Seattle **design** Commission

APPROVED **MINUTES OF THE MEETING**

May 21, 2009

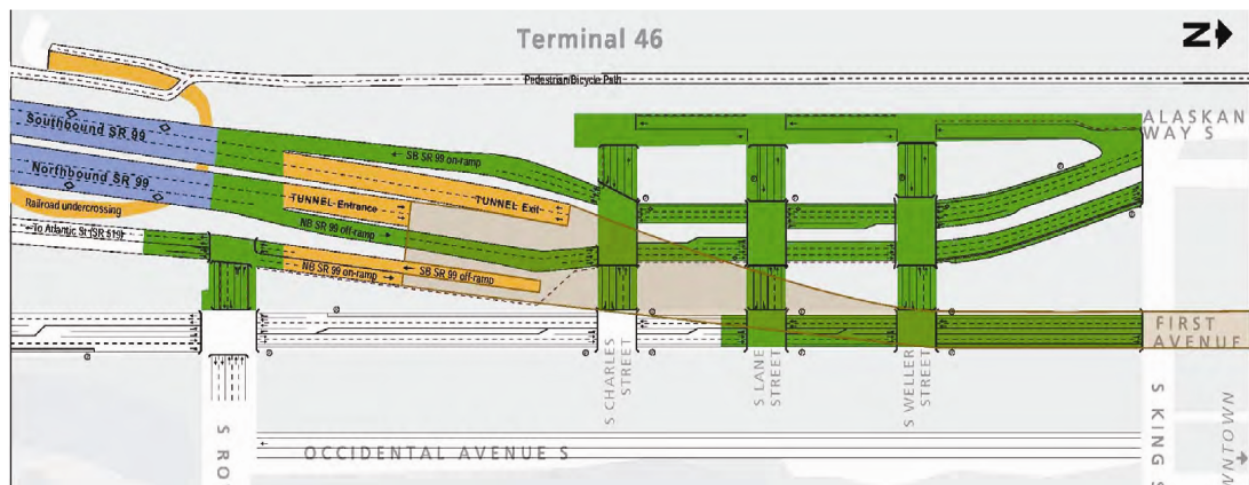
South Portal Concept A is the Preferred Concept. We like the graceful transition between the tunnel and surface streets in the city. New city blocks will be created. The concept minimizes elevated ramps and maintains an urban environment. The pedestrian bike trail will be included to the west of the southern terminus of the tunnel.
